IMPERIAL ROAD DESIGN MANUAL
REVISIONS July, 2014

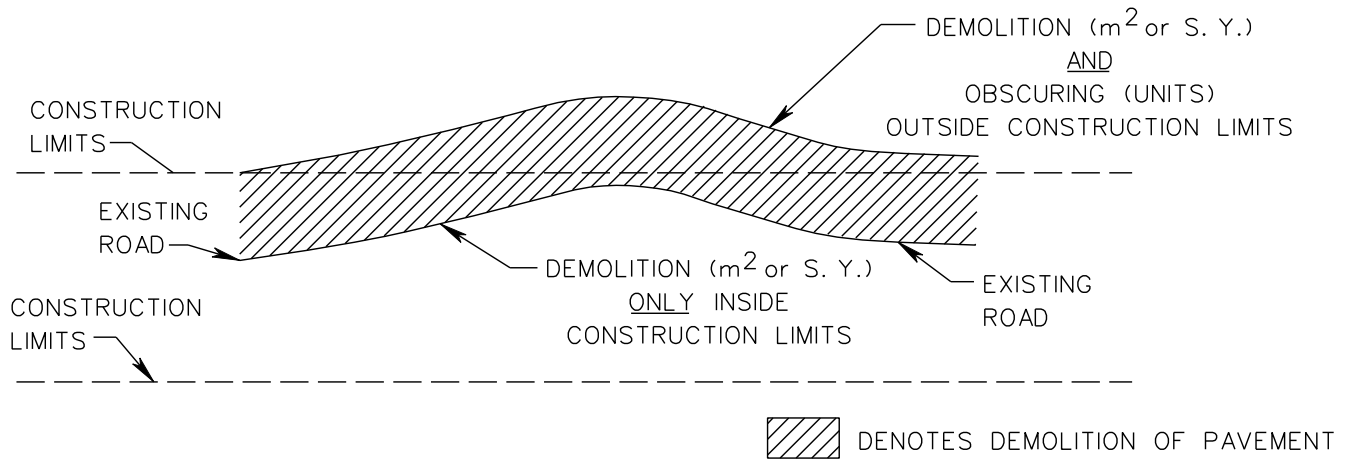
The following criteria are to be used in establishing the pay items for Demolition of Pavement and Obscuring Roadway.

EXAMPLES

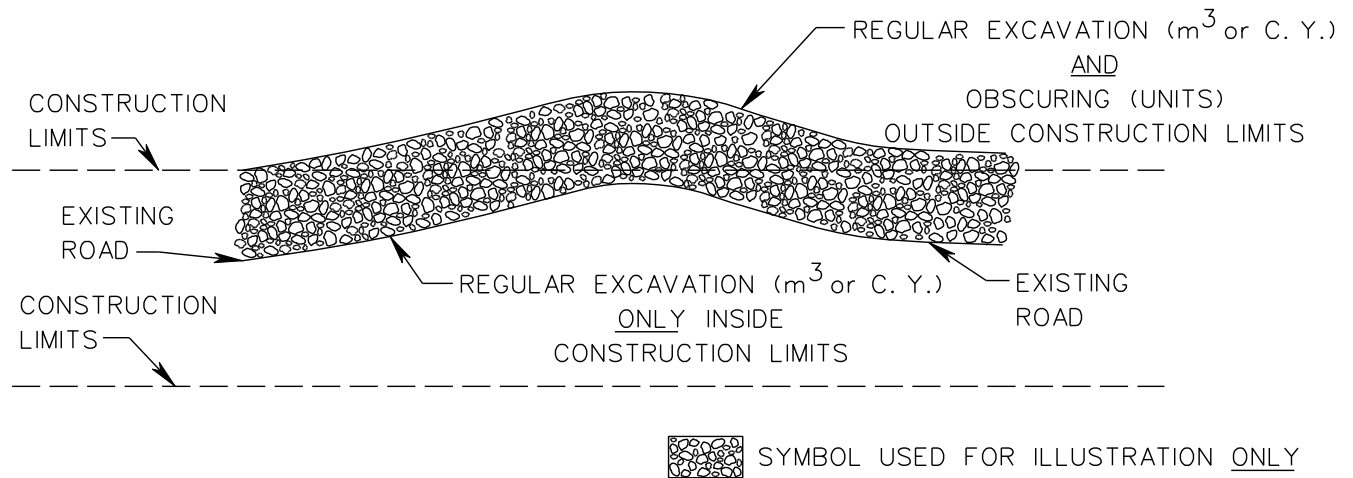
The demolition of cement stabilized, hydraulic cement and asphalt concrete pavement and shoulder structure courses located beyond the existing pavement structure will also be measured for payment.

Removal of all pavement and shoulder structures other than cement stabilized, hydraulic cement concrete and asphalt concrete pavement structure courses will be measured as regular excavation in accordance with Section 303 of the Specifications or as lump sum grading on Minimum Plan and No Plan projects.

FIGURE C-8-5 TYPICAL ENTRANCE RAMP

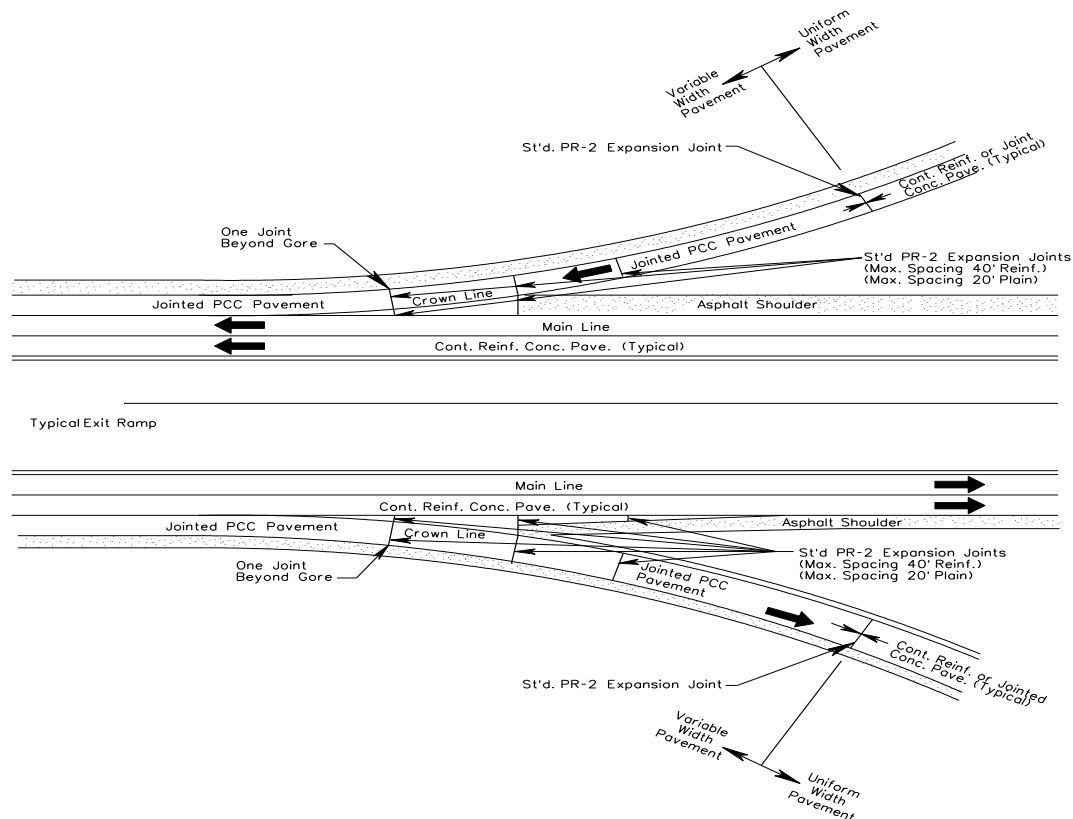
- Page C-82 – Revised “FIGURE C-8.1 RAMP GORE FOR EXIT RAMP” to add 14’ dimension to exit ramp pavement width.
- Page C-85 – Revised “FIGURE C-8.4 RAMP GORE FOR ENTRANCE RAMP” to add note about ramp left paved shoulder width.
- Page C-87 – Added the following language;

Each entrance and exit ramp must be examined on an individual basis to determine joint arrangements. The joint arrangement details are to be made a part of the plans.

Transverse expansion joints are to be provided in plain and reinforced concrete pavement as shown in Standard PR-2. Additionally, transverse expansion joints are to be provided at all ramp gores constructed of Portland Cement Concrete Pavement, either plain or reinforced.

The following sample drawings depict typical joint arrangements at entrance and exit ramps, and are not intended to be all encompassing.
